QUEENSTOWN LAKES DISTRICT COUNCIL

Hearing of Submissions on Proposed District Plan

Report 11

Report and Recommendations of Independent Commissioners Regarding  
Chapter 12, Chapter 13, Chapter 14, Chapter 15, Chapter 16 and Chapter 17

Reply Figure 2

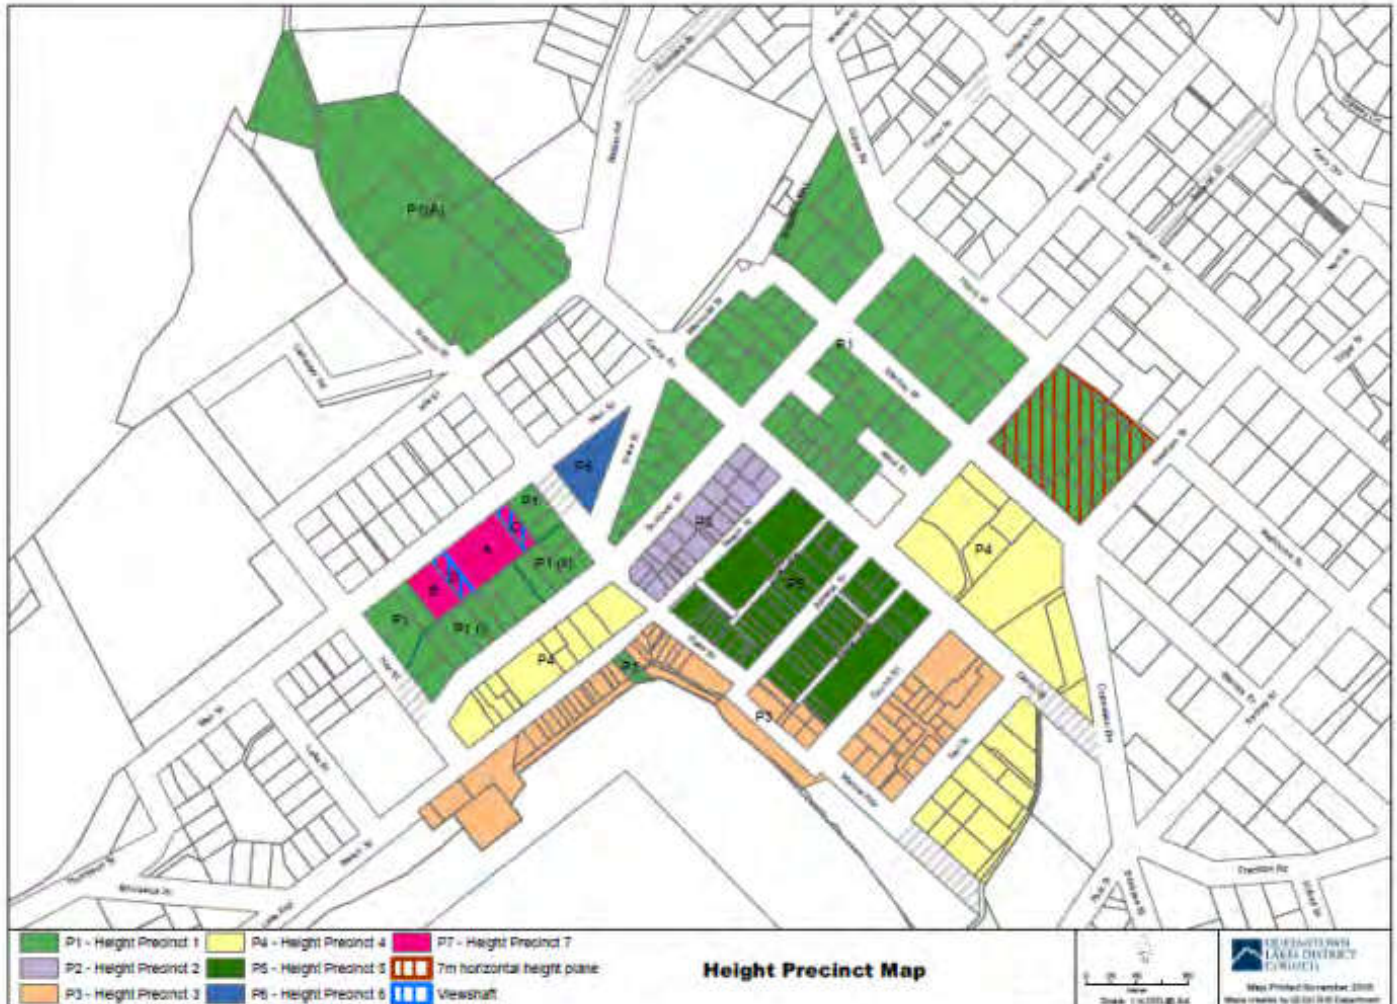
681. In her Reply<sup>561</sup>, Ms Jones responded to Mr Farrell's evidence and questions, by recommending that Areas E and F (as shown in notified Figure 2) be removed from Precinct 7 and replaced with Precinct 1, and consequential changes be made to Rules 12.5.10.4 and 12.5.10.1. These consequential changes included adding a rule to 12.5.10.1 that no building exceed a horizontal plane at 271.1/ 330.1 masl. The recommended rules in Appendix 1 to her Reply Statement would have the effect of providing the restricted discretionary activity status to buildings between 12 and 14m above ground level as in the rest of Precinct 1, while ensuring that anything above either 14m above ground level or 271/ 330 masl respectively would be non-complying. She considered this to be more efficient and effective than redraft Rules 12.5.10.4(e) and 12.5.10.4(f) that applied to this area in the version attached to the Section 42A Report.

698. The final issue with the view shafts related to queries we raised during the hearing about whether the view shafts should be movable or their shape able to be altered. Ms Jones was of the view that she did not consider this to be necessary as the eastern view shaft was set, and she reminded us that there were limited alternate locations for the western view shaft. Overall, she preferred fixing their position on Reply Figure 2.

699. Ms Jones did, however, reconsider the recommended location of the western view shaft (Area D), which she had moved to the location specifically sought in MSP's submission<sup>574</sup>. After taking into account Mr Williams's evidence, she recommended<sup>575</sup> that the western view shaft be repositioned approximately 13 m to the west to avoid the lean to roof form that Mr Williams referred to in paragraph 11 of his evidence summary.

700. The consequence of this was that recommended Area B was reduced in size and, due to the rising level of Man Street, the height enabled in the view shaft could be raised by 0.5 m without impeding on views from the street. This has the added benefit of enabling more design flexibility for the first floor beneath.

684. Included in Ms Jones' Reply Statement was her final recommended Figure 2 (Reply Figure 2). We include this below in order to aid in understanding the recommendations that follow. Reply Figure 2 is also included in our recommended Chapter 12 set out in Appendix 1.

701. We agree with the evidence of Mr Williams and Ms Jones on this point and accept Ms Jones' reasoning for the change in the location of the western view shaft. We recommend adoption of this change as shown on Reply Figure 2.

734. We recommend these rules be renumbered as Rule 12.58 and Rule 12.5.9, and be adopted with the wording set out in Appendix 1. This wording incorporates necessary consequential changes resulting from the revisions we have discussed above. We also recommend including as Figure 2 the Height Precinct Plan shown as Reply Figure 2 above.
